RECEIPT DATE: 7-29-19 **ONSITE SEWAGE DISPOSAL SYSTEM** P 965575

RE: 2385 Rt. 97
Cooksville, MD 21723
"Septic Plan Comments"

**SEPTIC SYSTEM INSTALLATION SITE PLAN**  
**2385 MARYLAND ROUTE 97**  
 ZONED: RC-DEO  
 TAX MAP 14 GRID 11 PARCEL 253  
 FOURTH ELECTION DISTRICT HOWARD COUNTY, MARYLAND  
 SCALE: 1" = 40' DATE: OCTOBER, 2018  
 SHEET 1 OF 1

**SEPTIC SYSTEM INSTALLATION SITE PLAN**  
**2385 MARYLAND ROUTE 97**  
 ZONED: RC-DEO  
 TAX MAP 14 GRID 11 PARCEL 253  
 FOURTH ELECTION DISTRICT HOWARD COUNTY, MARYLAND  
 SCALE: 1"=40' DATE: OCTOBER, 2018  
 SHEET 1 OF 1

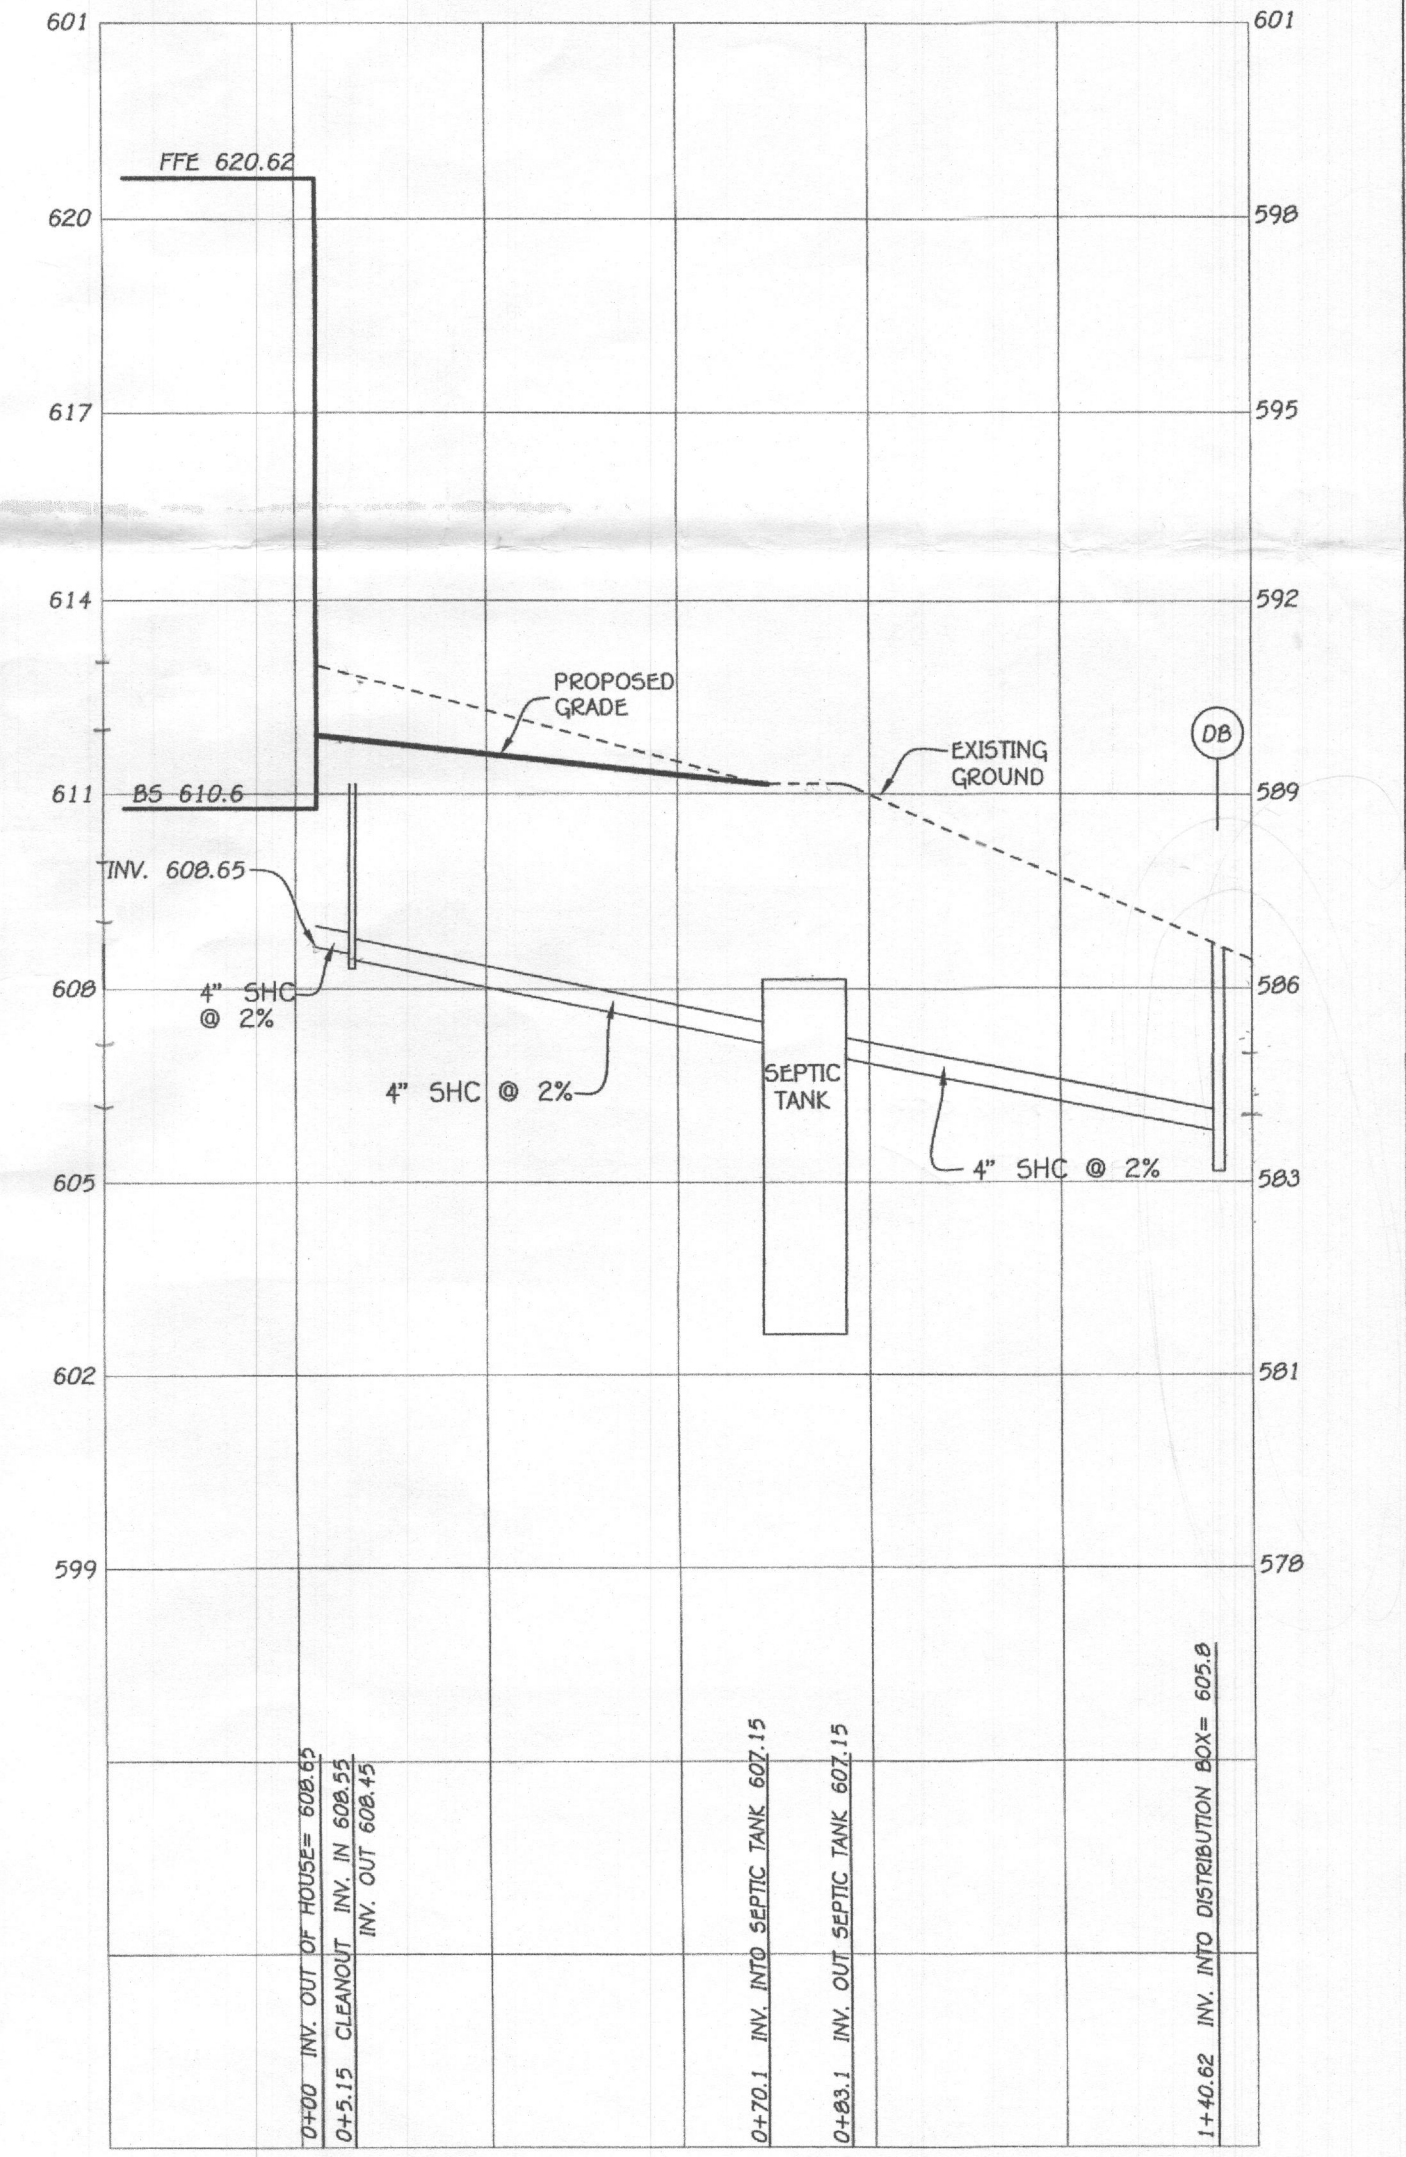
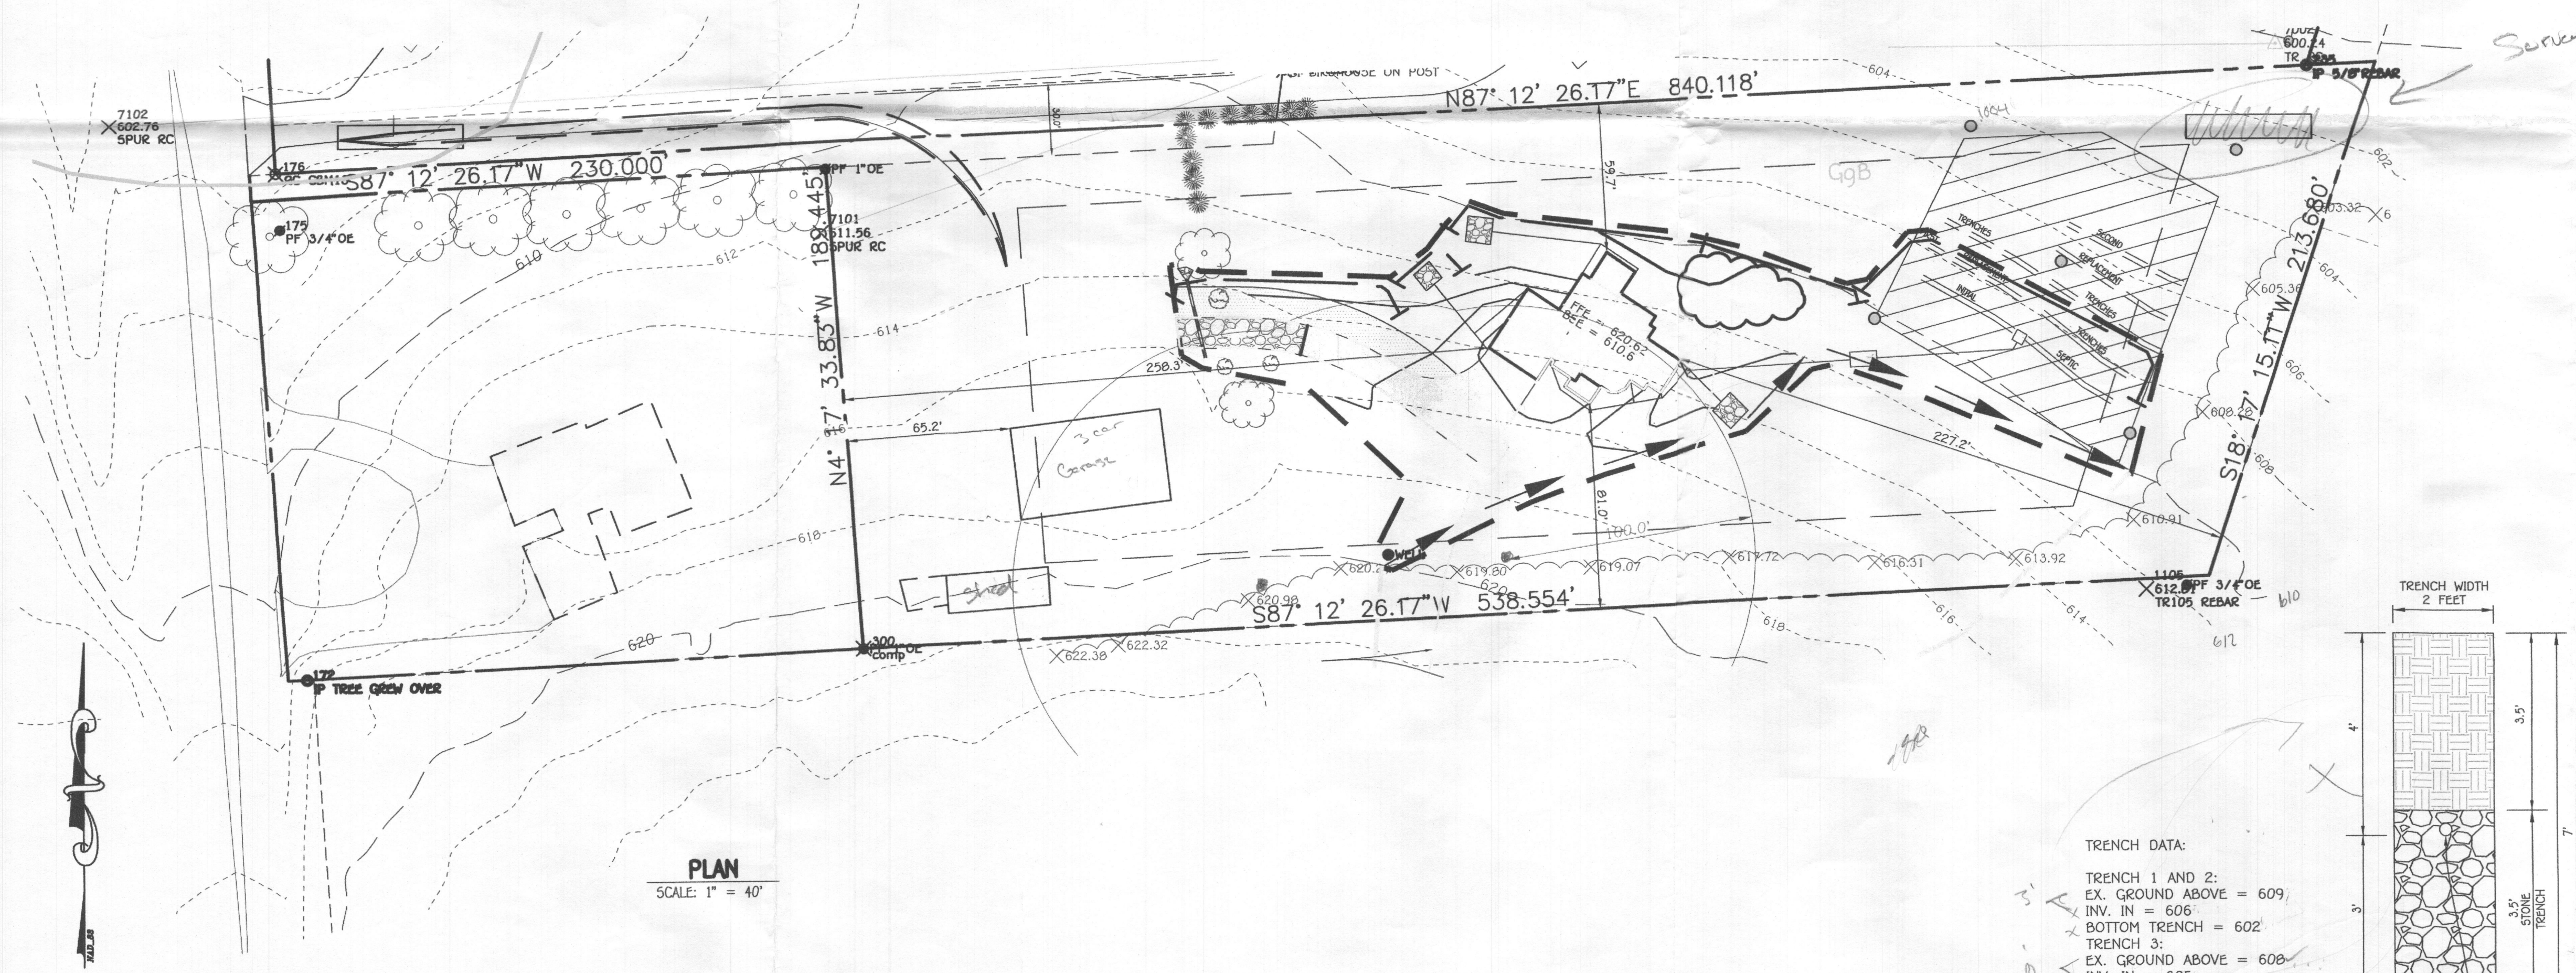
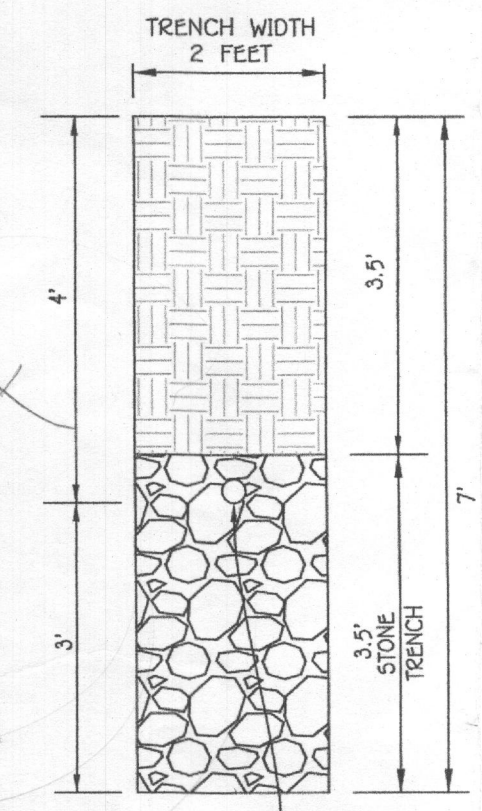
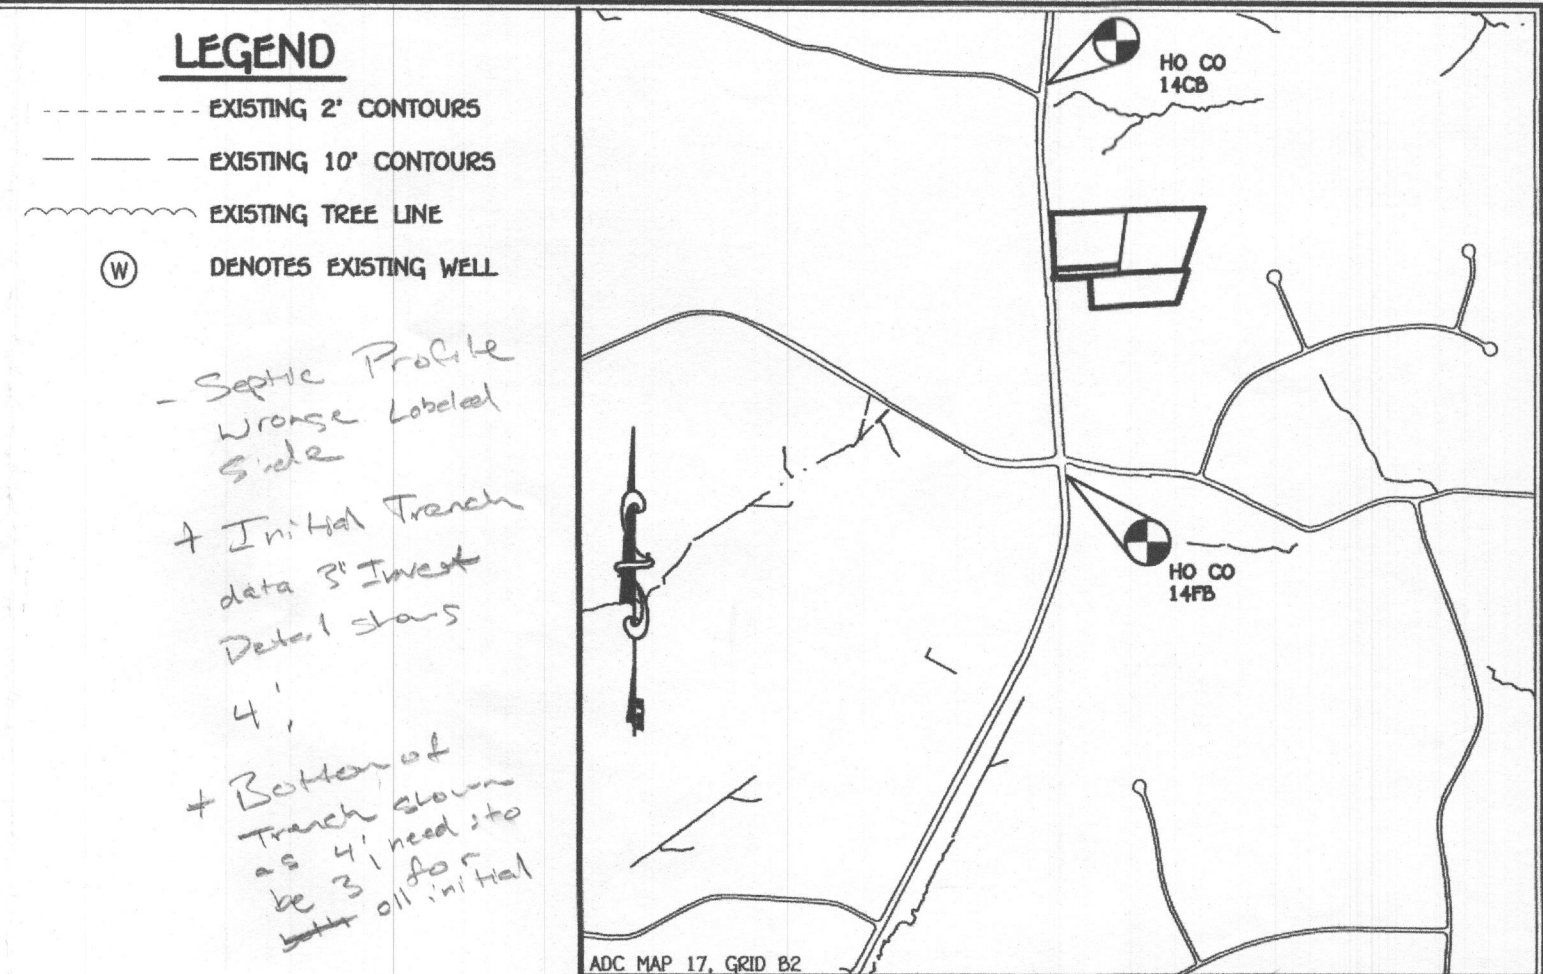
- Septic Profile W/zone Labeled Side
- + Initial Trench data 3' Invert Detail class 4'
- + Bottom of Trench shown as 4' head, 3' to be 3' for initial
- Invert to 2'
- Potential Basement Bedroom
- Septic Tank under center wall
- Rectangular?
- Alternate well sites need to be visible.
- clearly label trenches. Too many trenches.
- Show trenches whole
- Consider to remain or remove
- Label garage shed
- Put well tag with well
- Pull Trenches back to top of SDA
